**RE: Alameda Luxury Apartments
8400 Alameda Blvd NE
Conceptual Grading and Drainage Plan
Engineer's Stamp Date: 05/30/19
Hydrology File: C20D057**

Based upon the information provided in your submittal received 06/10/2019, the Conceptual Grading and Drainage Plan **is not** approved for action by the DRB for Site Plan for Building Permit. The following comments need to be addressed for approval of the above referenced project:

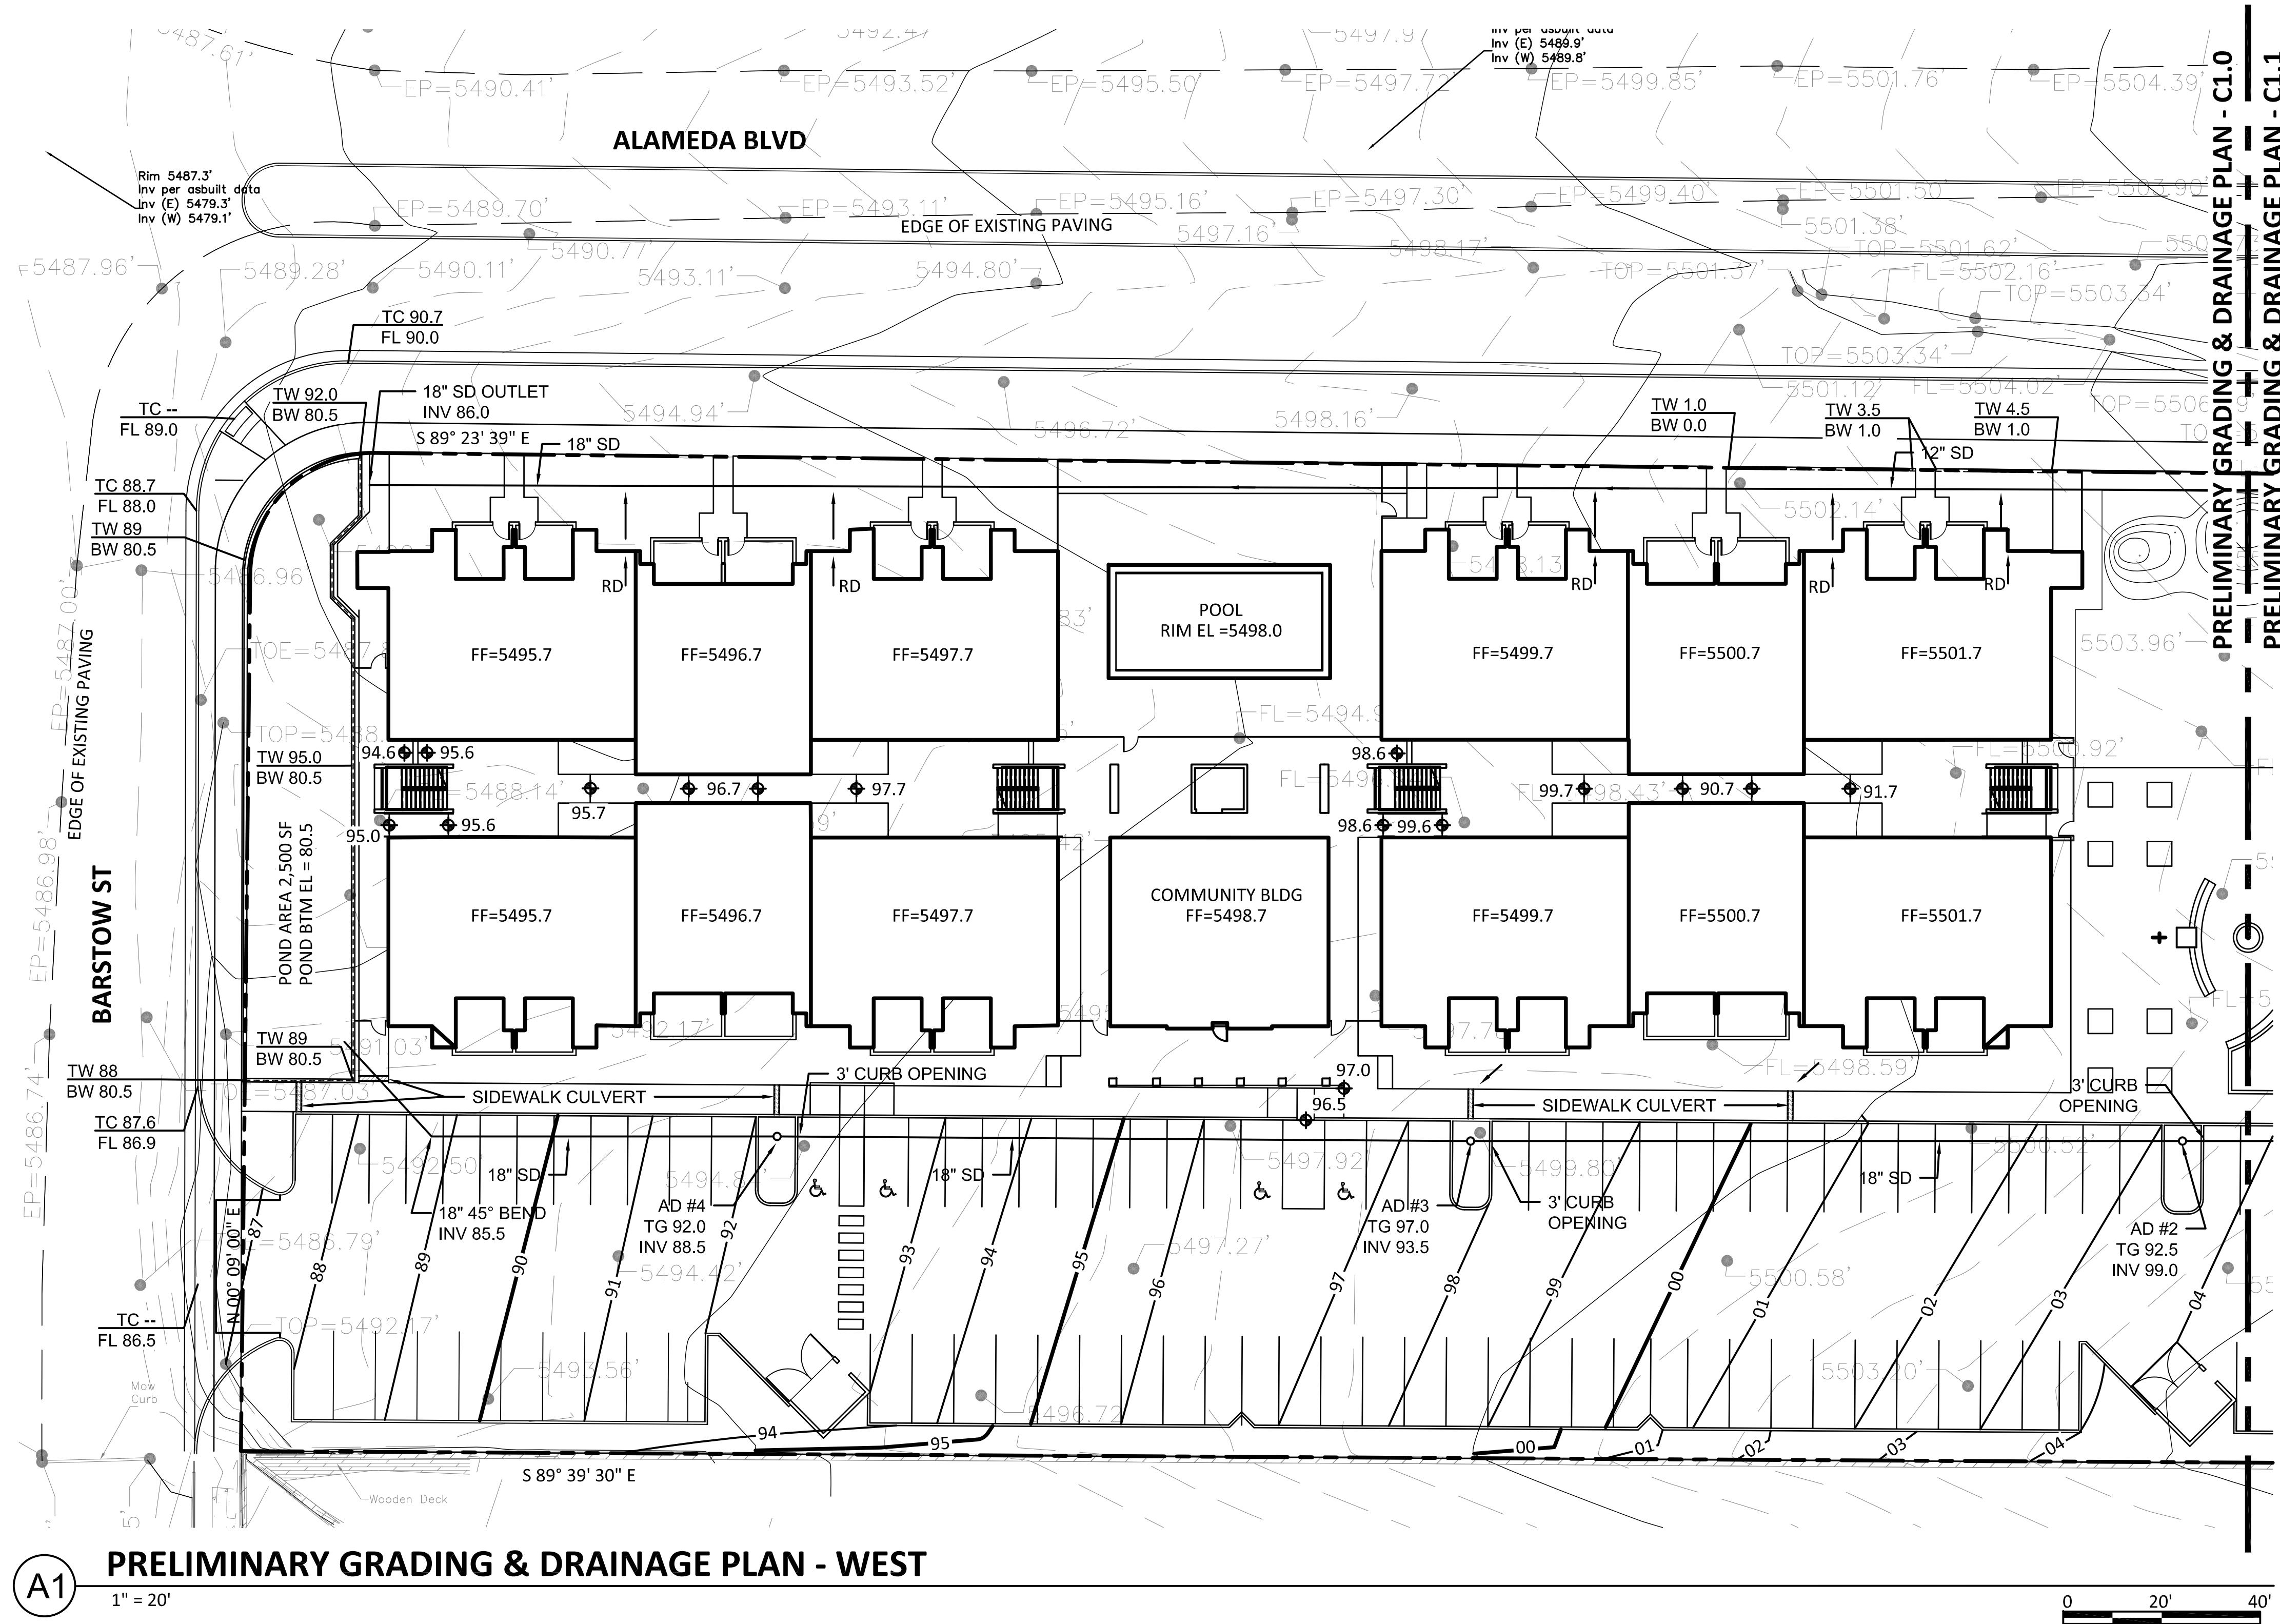
2. Please add a note stating "Not for Construction" on both sheets.
3. Under the Existing Conditions, please add a statement that this site is part of North Albuquerque Acres Master Drainage Plan (NAAMDP) with an allowable discharge rate of 2.38 cfs/ac.

4. Please provide a typical section of the detention pond along Barstow. Also the footer for the retaining wall must be within the property.
5. Please provide the capacity calculations for South lanes of Alameda Blvd. The drainage areas should also include the east adjacent development which discharges into Alameda. Per Chapter 22 Section 3.E (Street Hydraulics) of the DPM, the calculations are for the 10 year and 100 year storm event.

6. Per NAAMDP and the calculations from comment #5, a storm drain inlet should be required on Alameda just before Barstow. This inlet must drain to the north on Barstow to an existing storm manhole at the intersection of Oakland & Barstow.
